Access Compliance Report

Public Rights-of-Way

(Curb Ramps)

Intersection ID: 51478	Main Street: BENDERLOCH_DR	Cross Street: MEADOW_BOTTOM_RD	Location: W
ADA ID: 77BF98DC4796	Ramp Type: PerpDiag	Initial Pass/Fail: Pass	Overall Compliance: No
Severity Score: 0.25			
Codes/Mitigation Info/Possible Solution		Field Measurements/Component Compliance

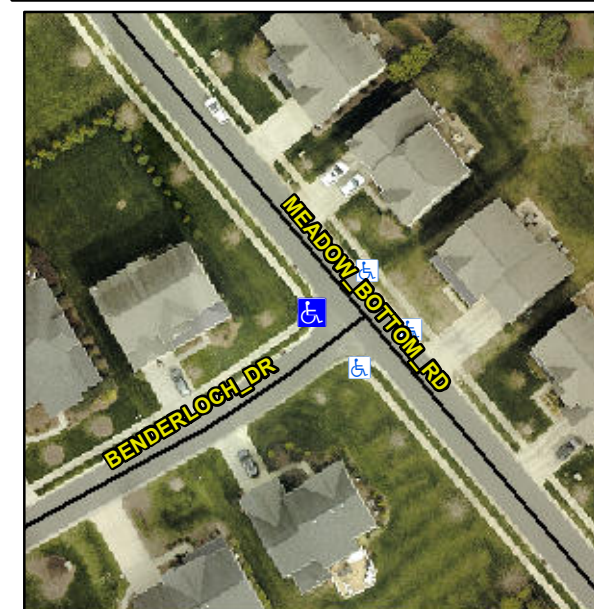
Not Found, R304.5.3, R304.2.2-Perp, R304.3.2-Para, R305.2

Compliance	Description	Data	Compliance	Description	Data
N/A	Ramp Length (in)	48.0	Yes	Ramp Slope (%)	6.1
Yes	Ramp Width (in)	48.0	No	Ramp XSlope (%)	3.4
N/A	Flare Type LT	Sloped	N/A	Flare Type RT	N/A
N/A	Flare Slope LT (%)	7.2	Yes	Flare Slope RT (%)	1.1
N/A	Flare Traversable LT?	Yes	N/A	Flare Traversable RT?	Yes
Yes	Landing Length (in)	48.0	Yes	DWS Provided?	Yes
Yes	Landing Width (in)	48.0	Yes	DWS Contrast?	Yes
No	Landing Slope (%)	2.1	Yes	DWS Length (in)	24.0
No	Landing X Slope (%)	3.0	Yes	DWS Full Width?	Yes
N/A	Landing Curb? (Y/N)	No	No	DWS Offset (in)	3.0
N/A	Shared Landing?	No			
Yes	Gutter Ponding?	No	Yes	Gutter Slope (%)	3.1
Yes	Gutter Lip Ht (in)	0.0	No	Gutter X Slope (%)	2.7
N/A	Painted X Walk1?	No	N/A	Painted X Walk2?	No
	X Walk 1 Direction	To SE		X Walk 2 Direction	To NE
N/A	X Walk 1 Width (in)	N/A	N/A	X Walk 2 Width (in)	N/A
	X Walk 1 Slope (%)	1.8		X Walk 2 Slope (%)	2.4
	X Walk 1 X Slope (%)	0.9		X Walk 2 X Slope (%)	1.1

Remove & Replace Curb Ramp With Two New Directional Ramps or Equivalent. Remove & Replace Gutter.
